Subject: Three Mile Island Nuclear Station, Unit 1 (TMI-1)
Operating License No. DPR-50
Docket No. 50-289
Response to Request for Additional Information -
Core Reload Methodology

This additional information is related to GPU Nuclear Topical Report TR-092P, Revision 0, "TMI-1 Reload Design and Setpoint Methodology," submitted on February 27, 1996 for NRC review and approval for in-house GPU Nuclear core reload design.

FIGURE 1. Maximum Allowable Peaking Limits

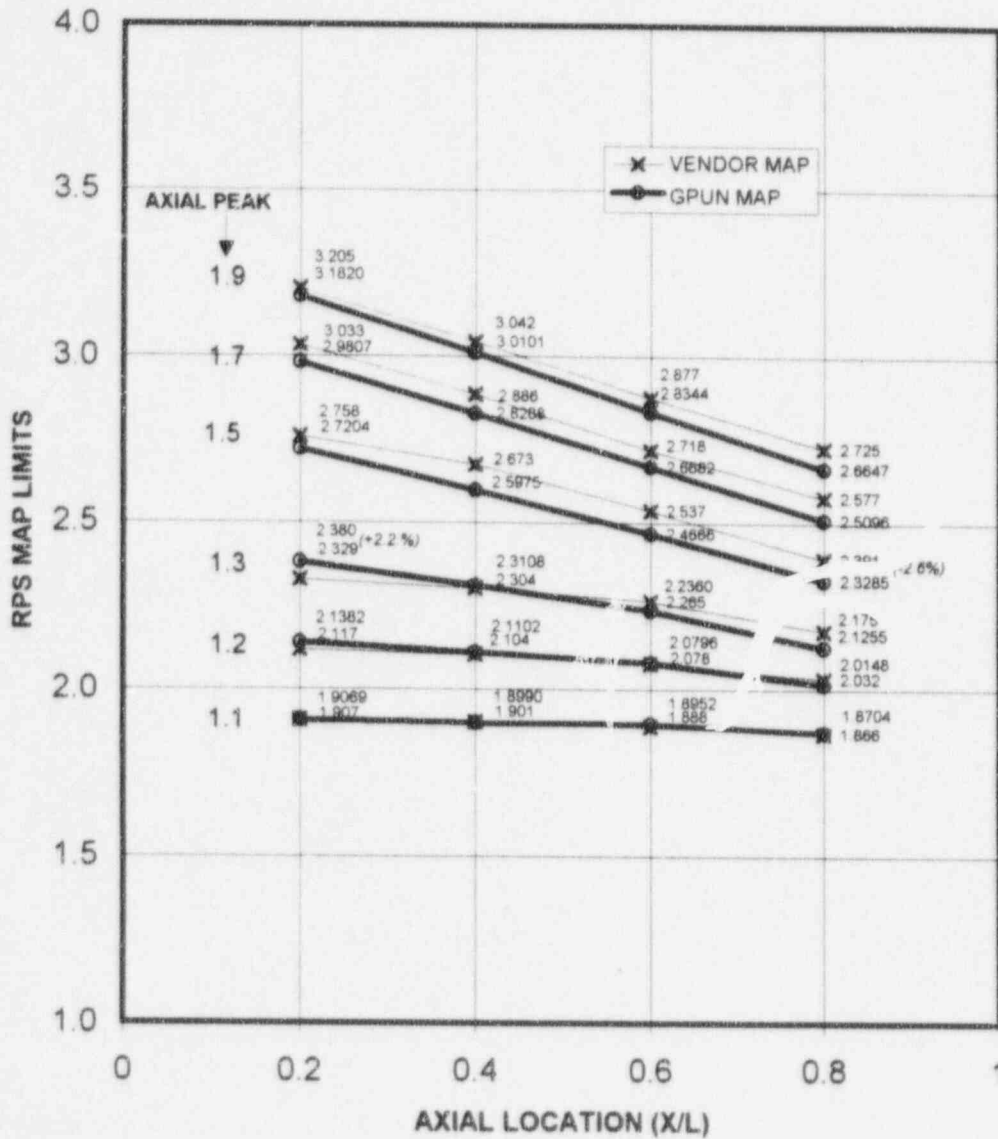
Figure A.9 page 149 indicates the maximum allowable peaking limits. The licensee's Maximum Allowable Peaking (MAP) limits for the axial peak values of 1.3 and less do not agree as well as those for axial peak values of 1.5 and greater. The licensee indicated that they did not base this analysis on Cycle 10 specific data but on composite bounding data from previous cycles.

It appears as though the licensee has not demonstrated their ability to repeat the vendor analysis.

As discussed with the NRC on August 19, 1996, GPU Nuclear has performed a confirmatory re-analysis of the entire RPS MAP limit analysis (axial peaks from 1.1 to 1.9) using recently available vendor-provided bounding thermal-hydraulic input data to provide a more direct comparison. The MAP limit analysis, as described in Section 3.6 of the subject topical report TR-092P, consists of two parts: (1) determination of the analysis target DNBR limits at two limiting pressure-temperature statepoints (low pressure and high temperature points as shown in Table 1), and (2) a parametric analysis for various axial power shapes by iterating the hot assembly power until the target DNBR limit is reached. The new comparative results are given in the attached Table 1 (for target DNBRs), and Figure 1 and Table 2 (for the MAP limits).

As shown in Figure 1 and Table 2, the new GPU Nuclear MAP results agree well with the vendor results. For the axial peaks from 1.1 to 1.2, the agreement of MAP limits is excellent (within 1%) and GPU Nuclear predictions for the axial peaks from 1.5 to 1.9 are 0.7% to 2.8% more conservative than those of the vendor analysis.

For the axial peak of 1.3 at the bottom portion of the fuel assembly ($X/L = 0.2$), the GPU Nuclear result ($MAP = 2.3803$) is 2.2% higher than the vendor result ($MAP = 2.329$). However, the impact of this 2.2% higher MAP limit at the bottom portion of the fuel assembly ($X/L = 0.2$) on the setpoint analysis is insignificant because, as illustrated in Figure 5.5 (page 110) of TR-092P (included in this response as Figure 2), the MAP limits are not limiting in the determination of the negative core offset (or axial imbalance) limit but are limiting for the positive core offset limit ($X/L \geq 0.5$). The GPU Nuclear MAP limits for the 1.3 axial peak would result in a more conservative setpoint than the vendor MAP limits considering that GPU Nuclear MAP limits are

more conservative than those of the vendor in the upper half of fuel assembly ($X/L \geq 0.5$) in Figure 1. Additionally, it is noted that the GPU Nuclear MAP limits are determined using the VIPRE-01, Mod 02 code consistent with GPU Nuclear Topical Report TR-087, whereas the vendor MAP limits are determined using the LYNXT code

Furthermore, as described in Section 3.6.3 (page 60) of TR-092P, the MAP margin verification analyses are to be performed during the reload design process to ensure reasonable peaking margins in determining the setpoints. This verification analysis is needed to determine the real DNBR margin by incorporating the actual axial power distribution data directly into VIPRE-01 replacing a smooth, mathematically-derived axial power distribution used in the MAP analysis. This MAP margin verification analysis will identify and correct any problem for cases where a non-conservative MAP margin exists.
